Re: Questions from the FCC

FCC ID:	JOYKC-SSSD-66K
Correspondence Reference Number:	8953
731 Confirmation Number:	EA94173

Figure 1.1. Cable connection of the external antenna (model: OA-S100)

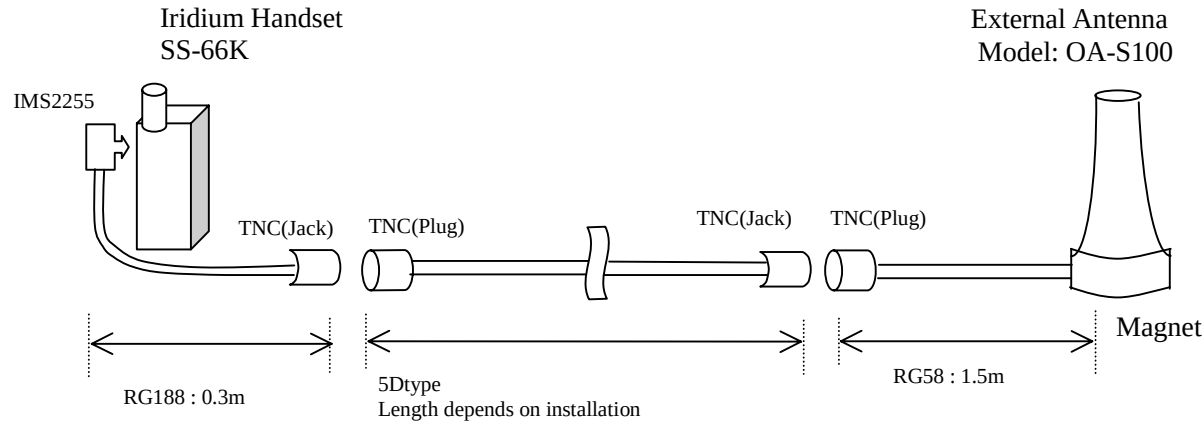
> 1. The issue on external antenna has not been addressed. RF exposure compliance
> for external antenna is dependent on the installation/operating conditions and
> the antenna gain.
>
> Please clarify with respect to 2.1091 or 2.1093 (if applicable) and determine
> if categorical exclusion applies or if MPE evaluation is needed.
>

Could you please refer Figure 1.1 and Figure 1.2 for connection of the external antenna?

These external antennas are generally mounted on the roof of a vehicle. In addition, we will give user a warning not to operate the Iridium mobile telephone when a person is within 8 inches (20 centimeters) of the externally-mounted antenna.

Since the separation distance of at least 20 centimeters is normally maintained between the transmitter's radiating structure and the body of the user, the Single Mode Iridium Handset with an external antenna falls into the category of Mobile Devices according to 2.1091(b). As each external antenna gain is the same as the internal antenna built in the Single Mode Iridium Handset, which uses TDMA technology for transmission, the Effective Radiated Power is 0.644 W.

Because the Single Mode Iridium Handset with an external antenna operates at frequency above 1.5 GHz and the ERP is less than 3 W, it is not subject to routine environmental evaluation for RF exposure according to 2.1091(c).

Figure 1. Sideview of Phantom and Iridium Handset with Antenna Extended Straight Out

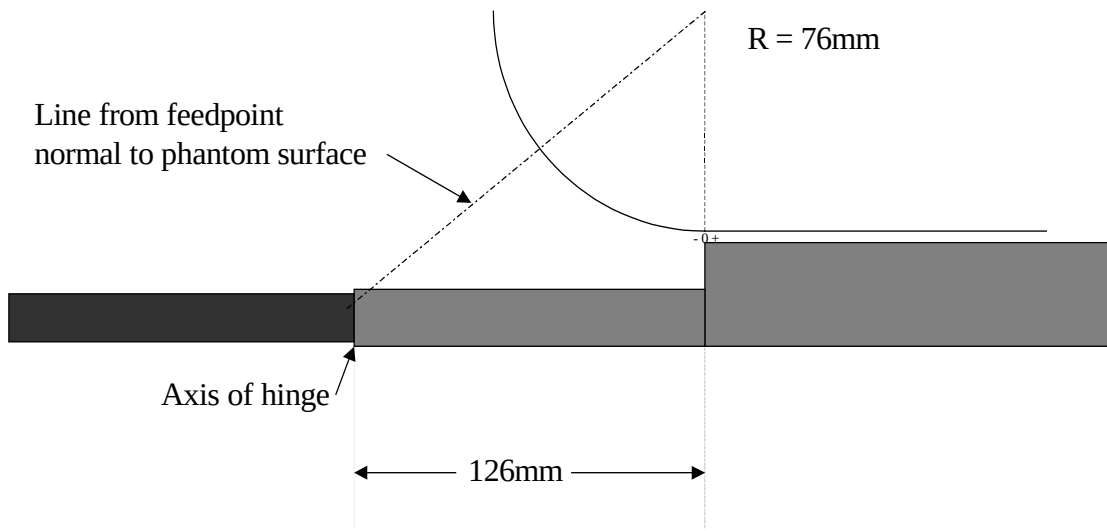
> 2. The antenna is offset to the left side of the handset which results in
 a
 > total of 6 extended antenna positions on either side of a head model. SAR
 > measurements near the top of a head model for antennas extending above the
 head
 > typically require special E-field probe positioning procedures and/or
 phantom
 > orientation (rotation). The antenna may protrude differently above the
 head
 > with varying separation distances when the phone is placed on the opposite
 side
 > of the head from those indicated in figures 5-7, and with respect to those
 > indicated in figures 2-4 for the Uni-Head or figure 8 of latest response.
 > Please identify the peak SAR location(s) obtained using the Uni-Head
 phantom
 > and relate it to the worst case exposure conditions for the 6 extended
 antenna
 > head exposure configurations. Information on worst case peak SAR location
 and
 > separation distances are needed to determine if and how the SAR obtained

using
 > the Uni-Head phantom can be applied to support worst case SAR at the top
 and/or
 > side of the head for the 6 extended antenna positions.
 >
 >

The following drawings show the closest distance of the “active antenna” element to the head simulation boundary. The positioning of the handset with respect to the phantom and the location of the antenna’s feedpoint relative to the phantom when the antenna is extended are also shown.

Figure 1 shows the case when the antenna is straight out, while Figure 2 shows the case when the antenna is tilted left or right. Notice that since the feedpoint is within 10mm of the hinge that the location of the feedpoint with respect to the phantom is constant (to a first approximation). The normal distance from the feedpoint to the phantom is thus 90mm plus or minus a few millimeters for all 6 extended antenna positions.

The SAR hotspot will be located somewhere along the antenna between the feedpoint and the tip. The tip of the antenna is 124mm from the hinge so the normal distance from the tip of the antenna to the phantom will be 196mm.

Since the radiating structure does not change when the antenna is retracted we can approximate the SAR to be expected in the extended position by the inverse square law. If the hotspot is located at the feedpoint then we would expect a maximum 1g SAR of about 0.03 W/kg, while if the hotspot is near the tip we would expect a value around 0.007 W/kg.
